AGENDA
ZONING BOARD OF APPEALS
Public Hearing Continuation

ZBA FY2017-00007 – North Square at the Mill District, Beacon Communities LLC, Request a Comprehensive Permit under M.G.L. Chapter 40B, to create a mixed-use, mixed-income development consisting of two new buildings containing 130 residential units, including 20% (26) affordable units, 22,000 square feet of non-residential space, approximately 299 parking spaces, and including site improvements, on approximately 5.3 acre leased site on a 12 acre property at 134 and 92 Montague Road, North Amherst (Map 5A, Parcel 42 and 139; Commercial (Com) and Residential Neighborhood (R-N) Zoning).

PROJECT APPLICATION REPORT

Project Name: North Square at the Mill District

Attachment 3

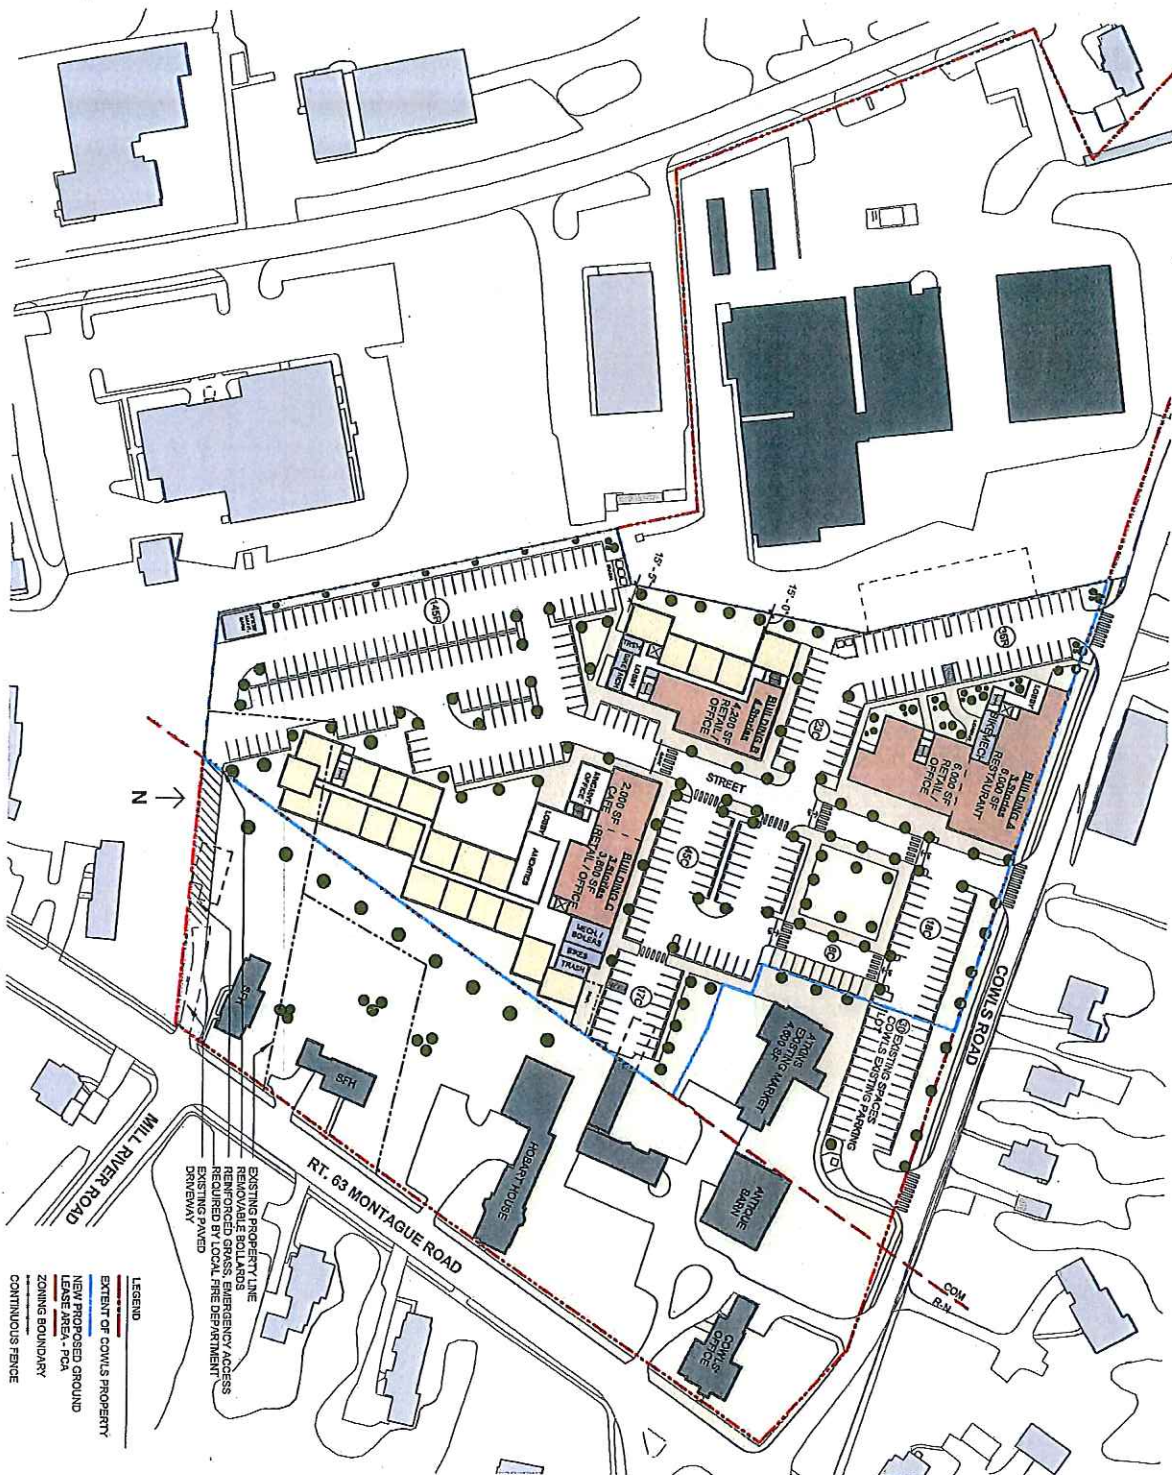
- **Issues to Consider:** In reviewing the plans, it appears a few of the islands are less than four feet wide. In addition, there has been some concern that the residential parking does not have adequate parking islands, especially within the west bank of parking. The applicant is requesting a waiver from Section 7.10 and to allow the development as it is shown on the site plan. In addition, Section 7.9 of the Bylaw states that the Board may waive or modify any provisions found in Section 7.0 (see conditions under the parking review section). The Board may want to ask for clarity from the developer as to what specific areas of landscaping they would like waived. The applicant has

stated that it may be difficult to reduce any space devoted to parking in order to accommodate additional landscaped islands. The board may also want to suggest high priority areas that need to have additional screening from adjacent properties such as the eastern lease and property adjacent to the Neighborhood Residential (R-N) zoning district.

L4.02

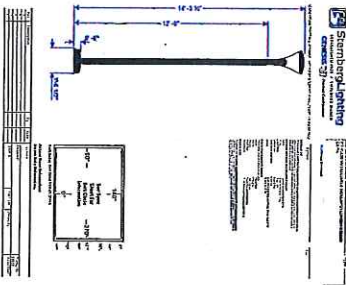
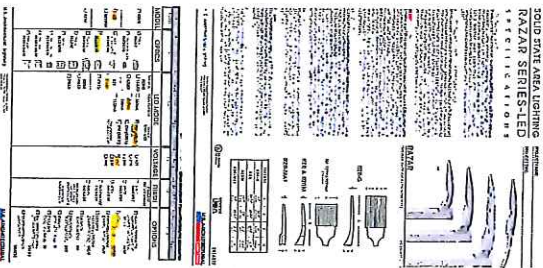
- **Issues to Consider:** The applicant has provided a photometric plan showing the site as having a low light impact. Yet, more detail needs to be addressed on lighting. The plans indicate the height and detail of the light fixture that will be within the commercial parking lot, yet does not show the height of the pole within the residential parking. The plans identify the light fixture top as being a modern razor style, typical in other multifamily or commercial projects. In addition, the Board may want to ask for the location and style of lighting to be found on the buildings and how this impacts the surrounding neighborhood. Finally, the developer has identified the front monument sign as having in-ground lighting shining up on to the words of the sign. They are aware the Board prefers downcast lighting, and have assured staff the light will only be directed on to the words of the sign itself and not into the sky.
